Wisconsin Department of Transportation

**Proposal #30: 1517-75-72, WISC 2017 345
USH 10 – USH 10/STH 441
County CB – Oneida St
Midway Interchange Mainline
USH 10
Winnebago County**

This is Addendum No. 01, which provides for the following:

Addendum No. 01
 ID 1517-75-72
 Revised Sheet 182
 May 31, 2017

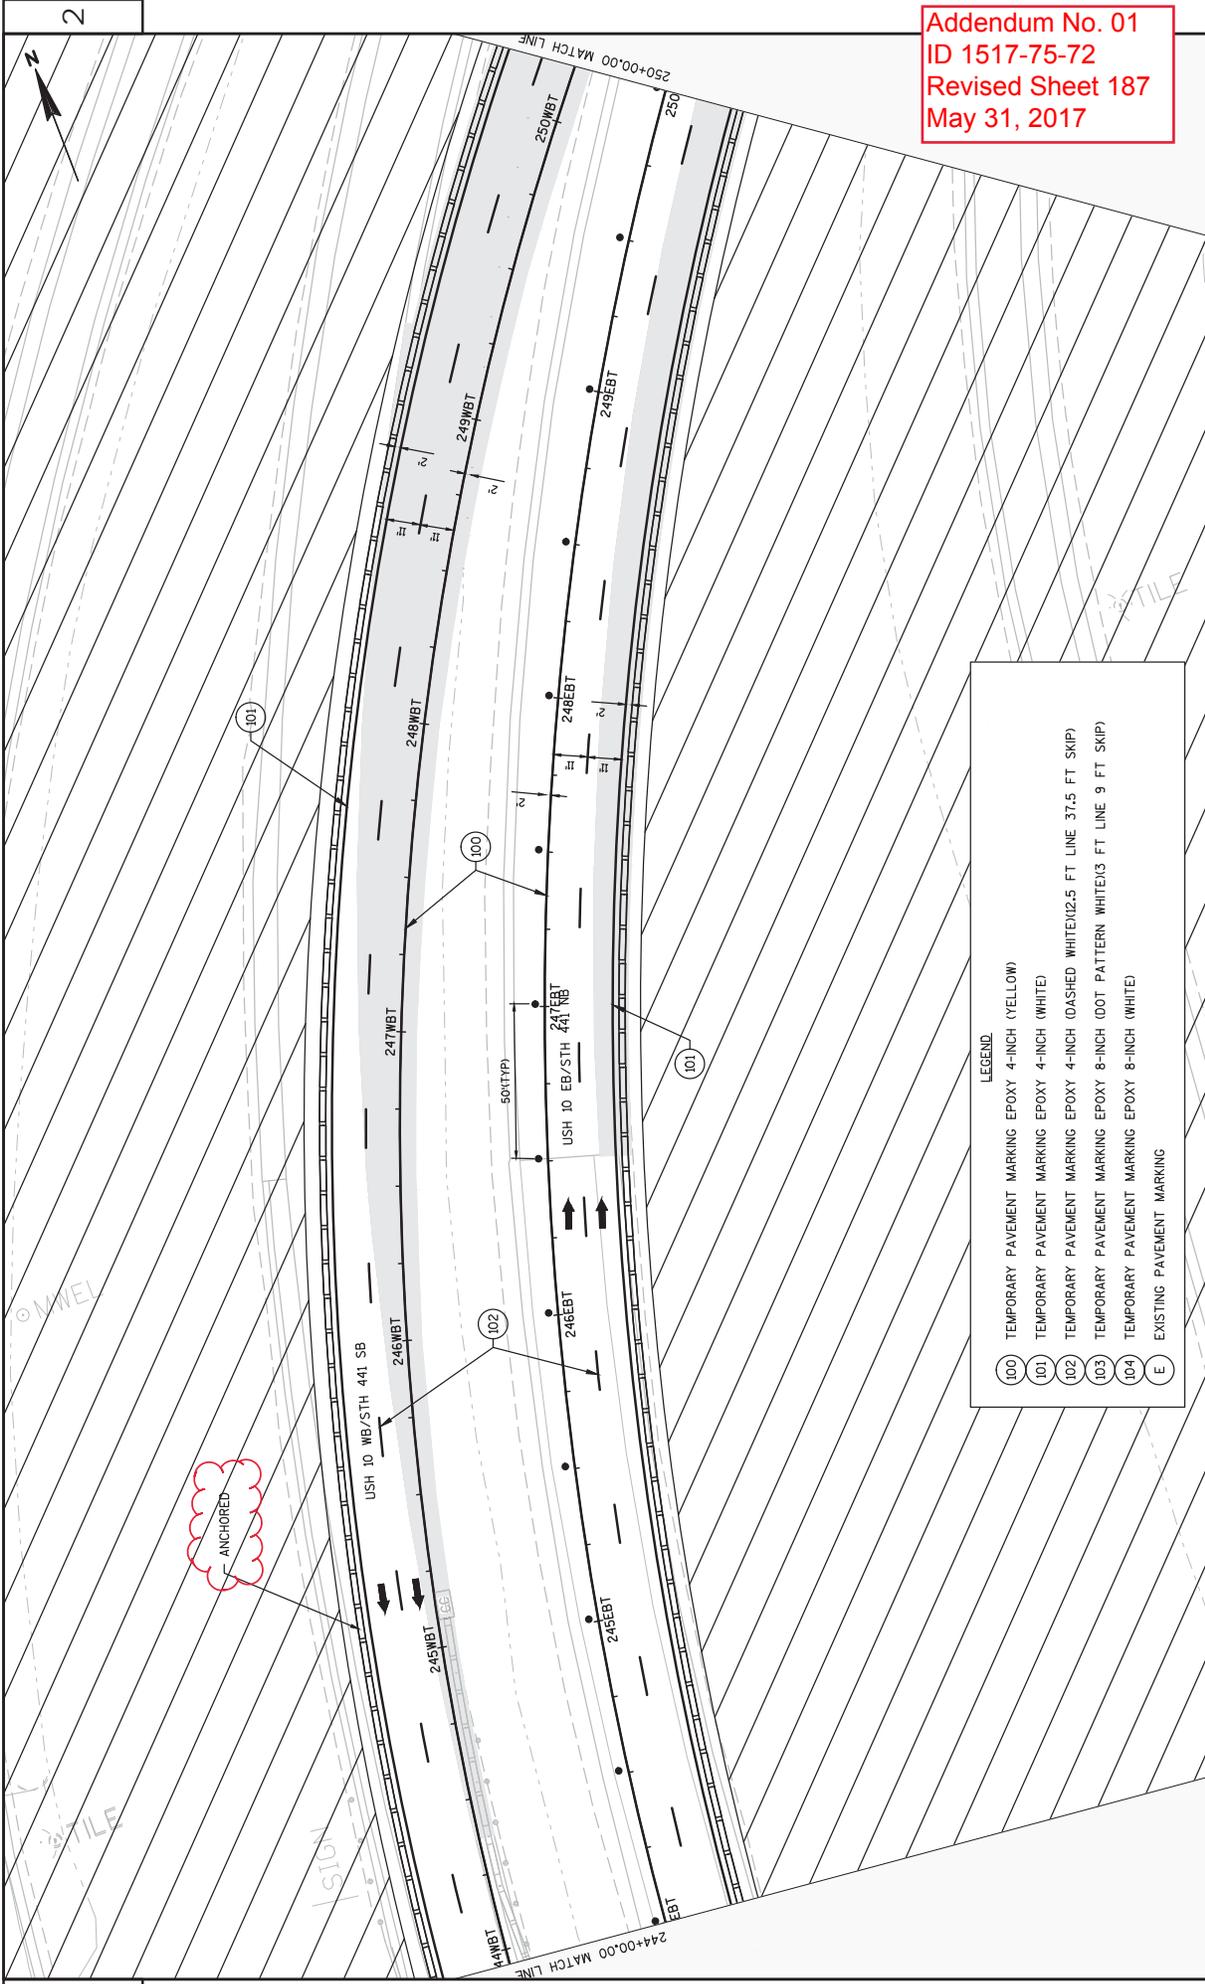
181	Traffic Control Stage 1A – Added Temp. Raised Pavement Markers
182	Traffic Control Stage 1A – Added Temp. Raised Pavement Markers
187	Traffic Control Stage 1 A- Added location for Anchored Barrier
188	Traffic Control Stage 1 A- Added location for Anchored Barrier
189	Traffic Control Stage 1 A- Added location for Anchored Barrier
190	Traffic Control Stage 1A – Added Temp. Raised Pavement Markers and location for Anchored Barrier
195	Traffic Control Stage 1A – Added Temp. Raised Pavement Markers
196	Traffic Control Stage 1A – Added Temp. Raised Pavement Markers
199	Traffic Control Stage 1A – Added Temp. Raised Pavement Markers
206	Traffic Control Stage 1A – Added location for Anchored Barrier
274	Miscellaneous Quantities – Stage 1 B Earthwork Station has changed
275	Miscellaneous Quantities – 311.0110 Breaker Run quantities revised
276	Miscellaneous Quantities- 455.0605 Tack Coat quantities revised and 601.0411 title in MQ's only changed.

Addendum No. 01
ID 1517-75-72
Added Sheet 233A
May 31, 2017

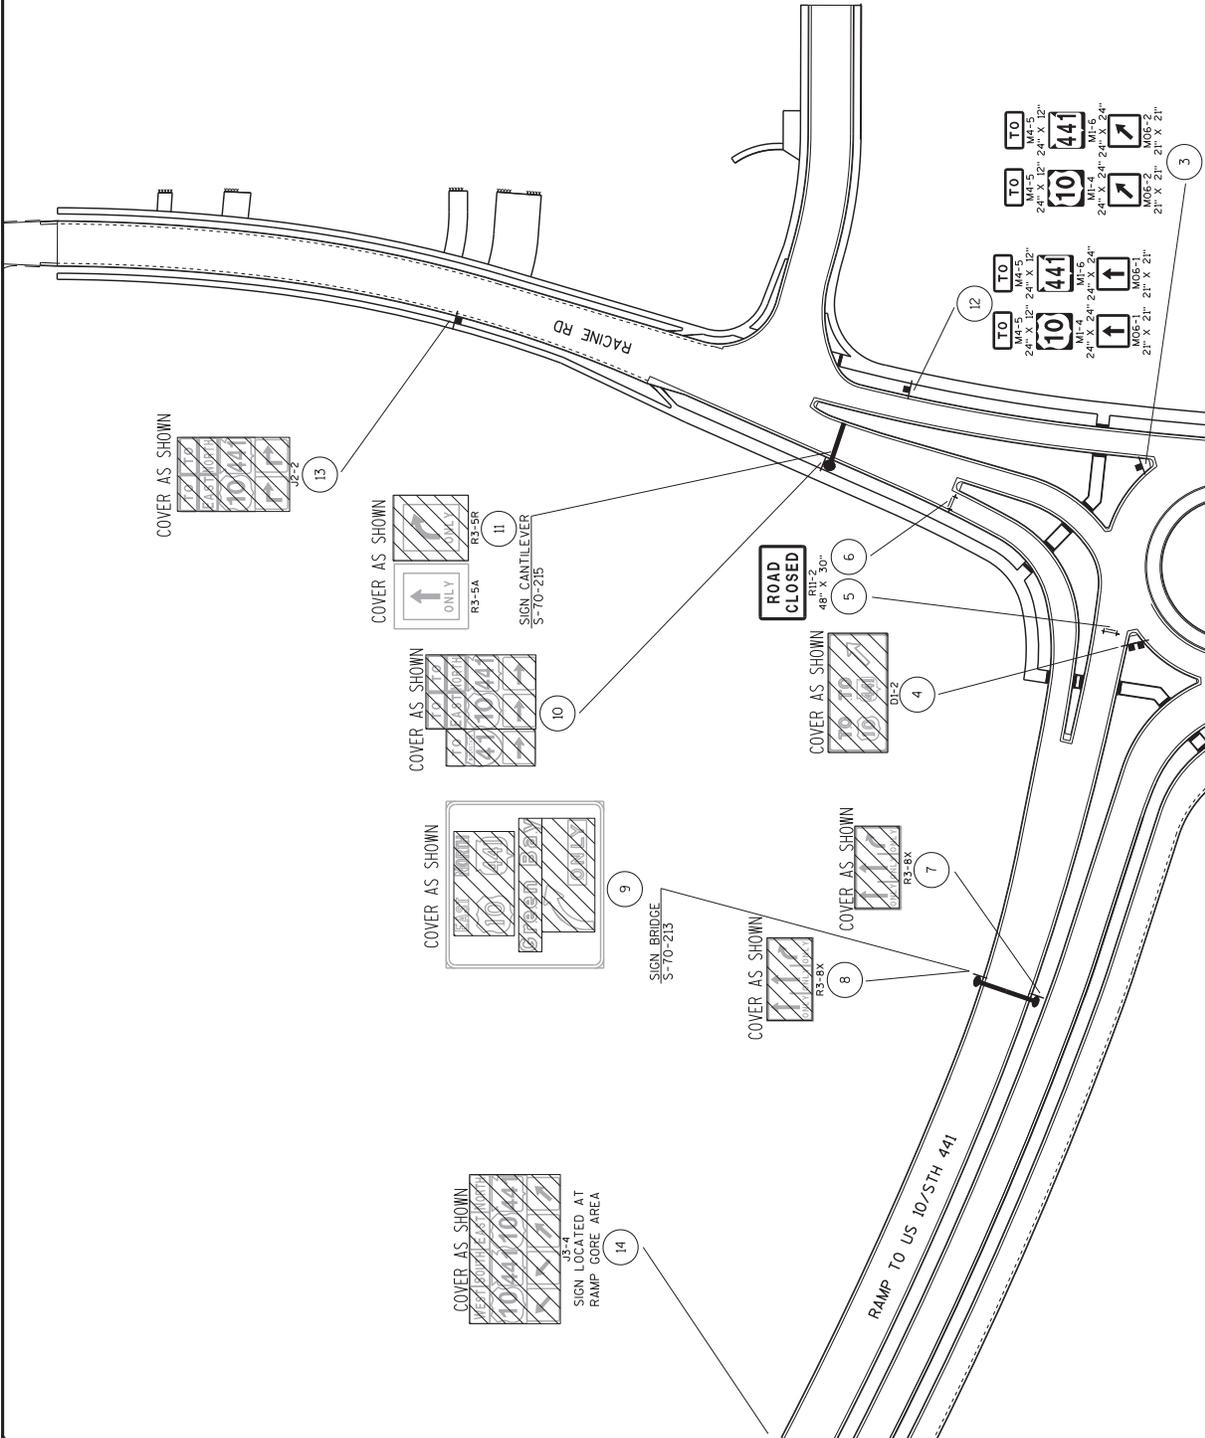
Added Plan Sheets	
Plan Sheet	Plan Sheet Title (brief description of why sheet was added)
52A	Construction Detail- Lane Closure- Regulatory Speed Reduction Without Barrier
233A – 233C	Traffic Control Detail – Racine Rd NB On-Ramp Closure
293A	Miscellaneous Quantities – Signing Type I and II
